City of Tarpon Springs, Florida

**BOARD OF ADJUSTMENT AGENDA
WEDNESDAY, APRIL 22, 2026
6:30 PM - CITY HALL AUDITORIUM**

STAFF REPORT

Application No. / Project Title: #26-17 (Mastriano)
Staff: Allie Keen, AICP, Principal Planner
Applicant / Owner: David Mastriano
Property Size: +/- 0.23 acres
Current Zoning: R-100 (Single Family Residential)
Current Land Use: RL (Residential Low)
Location / Parcel ID: 716 Sunset Drive / 11-27-15-87786-017-0080

1 **SITE PLAN**
SCALE: 1" = 20'

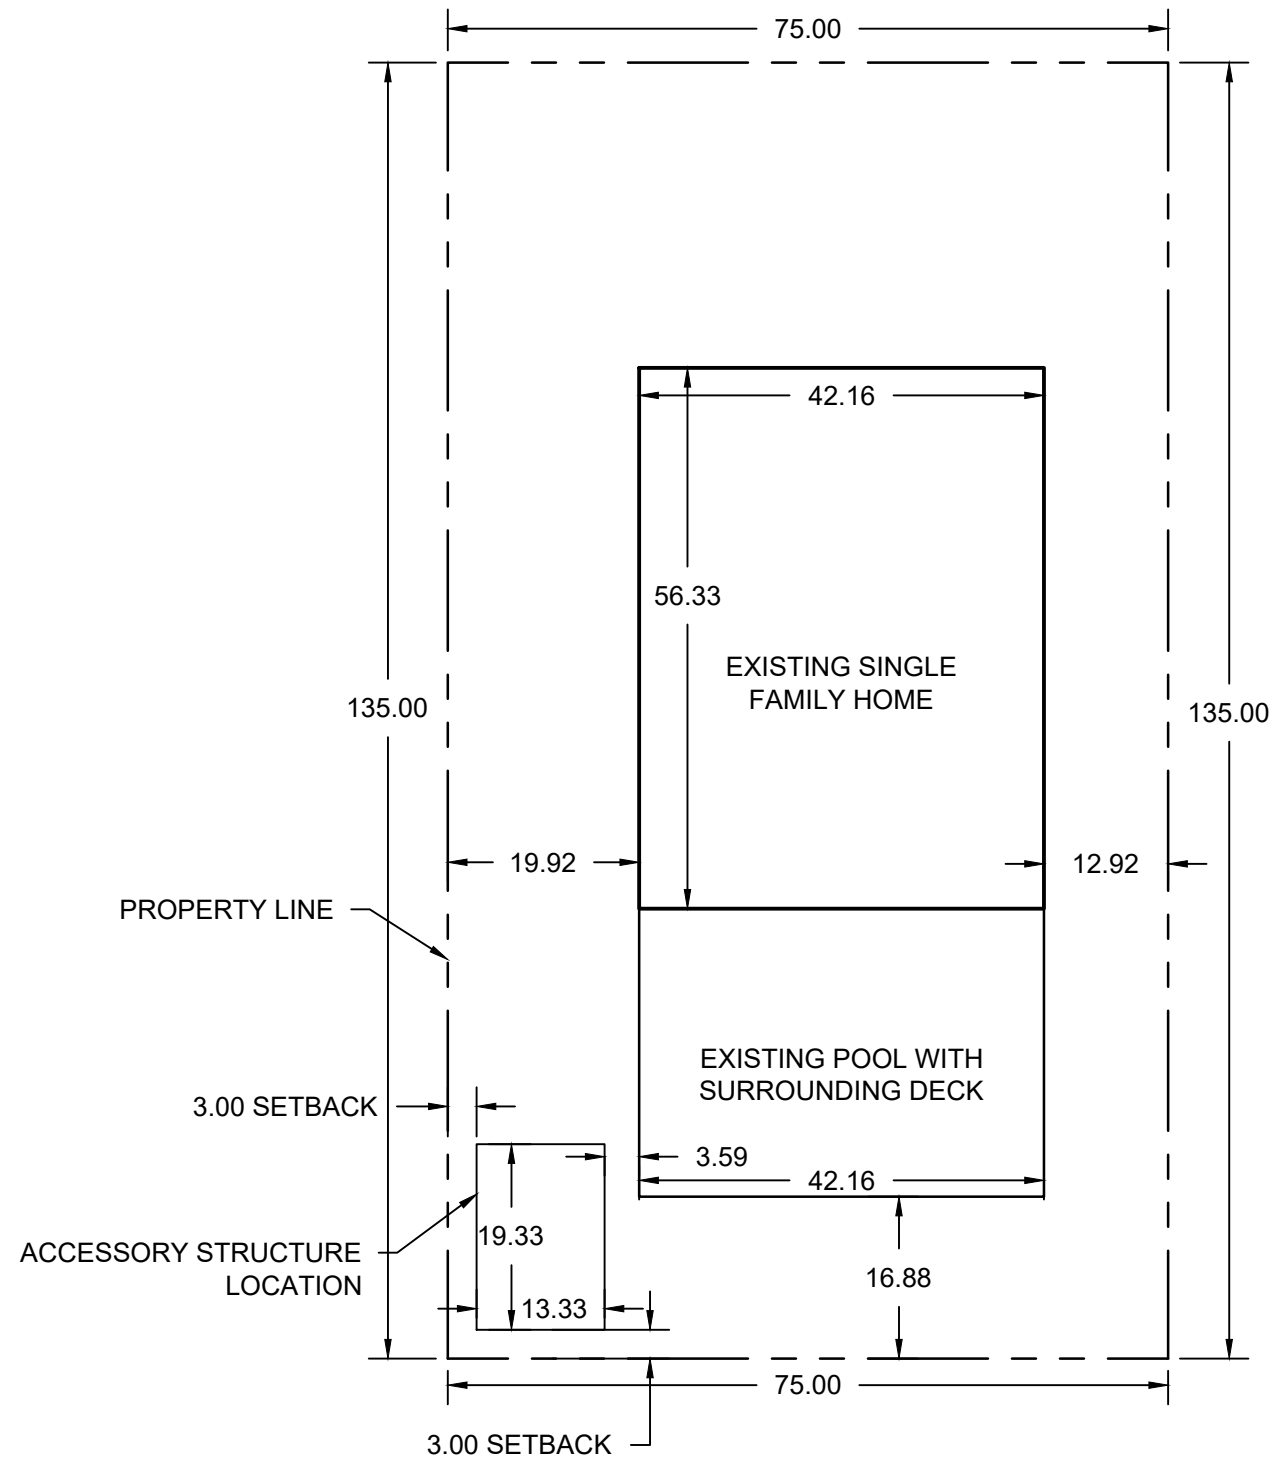
2. Section 25.02(D)(6) of the Land Development Code (LDC) provides for a minimum 10 foot side yard setback and 30 foot rear yard setback. According to the provided site plan the proposed structure will have a side and rear yard setback of 3 feet.

3. The layout of the home, existing pool and deck limit the potential location of a storage shed. The existing improvements have a side setback of just under 20 feet. If the 10-foot side setback was observed, it would necessitate the shed being reduced in width and likely require the structure to be up against the pool deck, limiting accessibility to the rear yard. The 30 foot rear setback would require the structure to be sandwiched between the home and existing privacy fence, limiting the accessibility along the side of the home. The proposed shed location allows for adequate access to the side and rear yard, around the structure, and provides an appropriate distance between the pool and shed, while still preserving the usability of the yard.

4. There is an existing 6-foot tall privacy fence on the subject property. The shed is proposed to have a height of 10 feet (measured to the eave). The fence will provide screening of a majority of the shed to neighboring properties.

5. Per LDC Section 36.01, storage sheds that are 200 square feet in area or less may have a reduced side and rear yard setback of 5 feet. Accessory structures exceeding 200 square feet are required to meet the minimum zoning district setbacks. If the proposed structure size was reduced by 58 square feet, the reduced setbacks would apply, however, they would still be larger than proposed by the applicant.

SITE PLAN

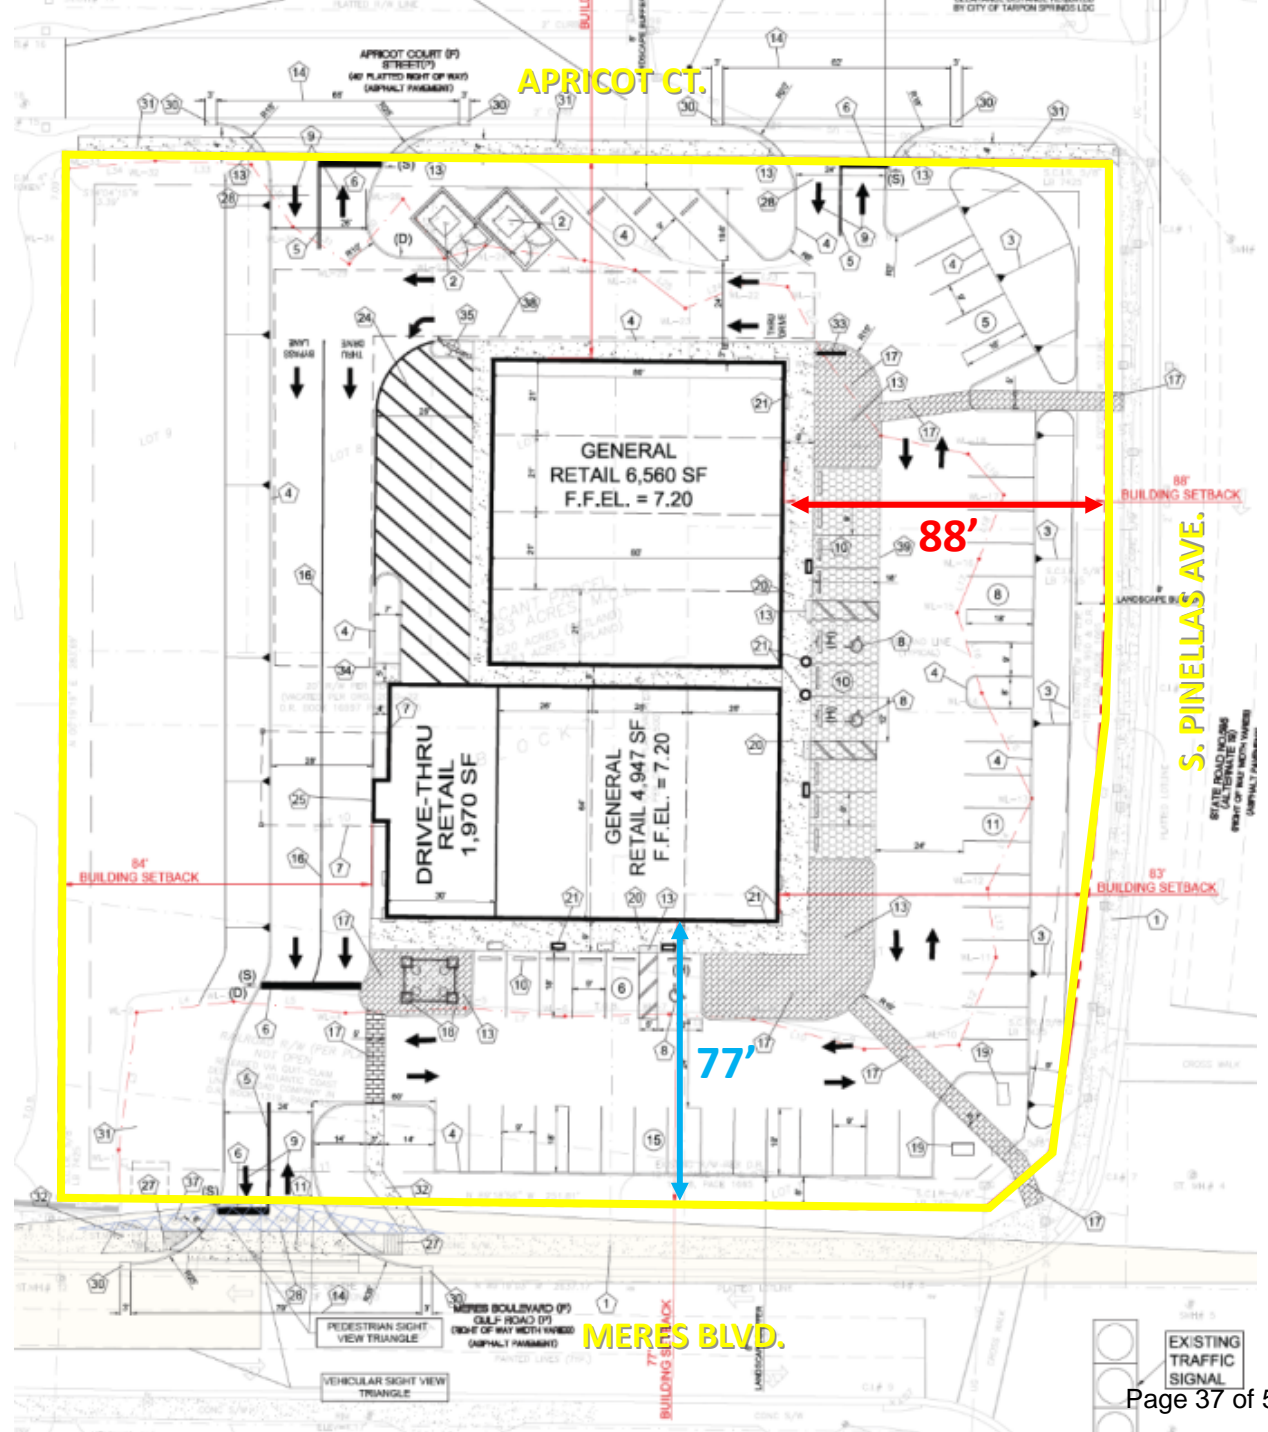
Can you provide an explanation as to why it is necessary to have a full two rows of parking (with the driveway aisle) fronting both Meres Blvd. and Pinellas Ave.? Is there a possibility to reduce this down to only 1 row of parking and narrower drive lane?

UPDATE AFTER TRC MEETING: *Please provide a written narrative of the explanation provided at the TRC meeting that can be provided to the Board member.*

NEW COMMENT AFTER TRC MEETING: This property is regulated by the SmartCode. The SmartCode requires 1 parking space per 1,000 sq.ft. For retail uses. Based on the proposed building size, only 42 parking spaces are required. Please update the site data table accordingly.

Currently, there are 65 spaces proposed. With the reduced parking, does this provide any flexibility in the site layout to move the building closer to the street?

For retail uses, parking demand works best when parking is grouped together and clearly visible and accessible from the street. That's how customers expect to use the site. We are required to provide 41 parking spaces based on the smart code for the proposed use and we are providing 59 spaces. If frontage parking rows is removed, we lose $15+19 = 34$ spaces which is major reduction and would leave the site without enough parking to support retail use. As you can see in updated plans that we did remove some parking spaces and proposed outside sitting area for the users/customers and also added one row of parking to be with pervious pavement.

On top of that, the site has a drive thru and by-pass lane, required fire and emergency access and carefully engineered internal circulation based on City, County and FDOT standards. If we remove frontage parking rows or narrow the drive aisle, the site no longer works as circulation breaks down, emergency access is compromised and the drive thru operation is disrupted.

We understand the intent of the Smart Code, and this plan balances that intent with the real world operational requirements of the site. There is no excess parking but it is minimum layout that allows the project to meet its parking requirement, operate safely and function as a viable retail development.

Please see enclosed updated site plan. The required number of parking spaces is 41 spaces and we are proposing 59 spaces.

As explained earlier, we can't remove the additional parking spaces that are in frontage and we will lose 34 spaces which is not enough parking to support the retail use. As we have a drive thru user with general retail users, we had to separate those users and account for the parking spaces for each users. Also, if we move the building close to street, we will have empty space in the back of the buildings by the bypass & drive thru lanes which we can't use for anything and on top of that we won't be able to align the access as we currently have.

In response to SmartCode guidance and because additional parking is not preferred, we revised the first row of parking adjacent to the building by eliminating a few spaces to create an outdoor seating area (to be finished
